DEVELOPMENT REVIEW BOARD REPORT

22-DR-2006
Chaparral High School

Request approval for site plan and elevations of campus redevelopment at Chaparral High School.

erb landscape plan

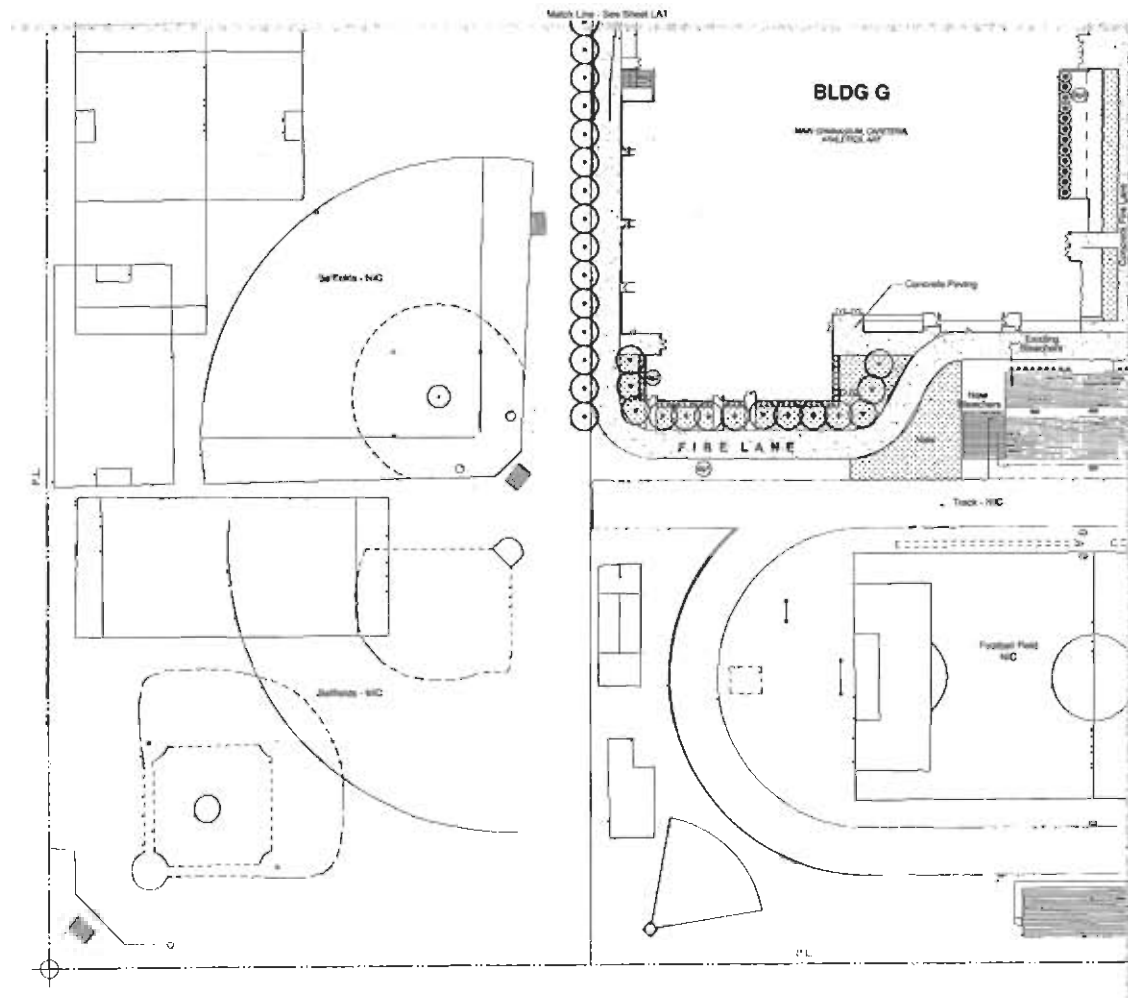
8. The Landscape plan shall be revised to show compliance with the City Code section 49-244 or as approved by water resources. Any proposed changes to the landscape plan shall return for City Staff review.

9. At time of final plans review the applicant shall provide the letter from a native plant salvage contractor stating there are no native plants on site and this project has met the requirements of the Native Plant Ordinance.
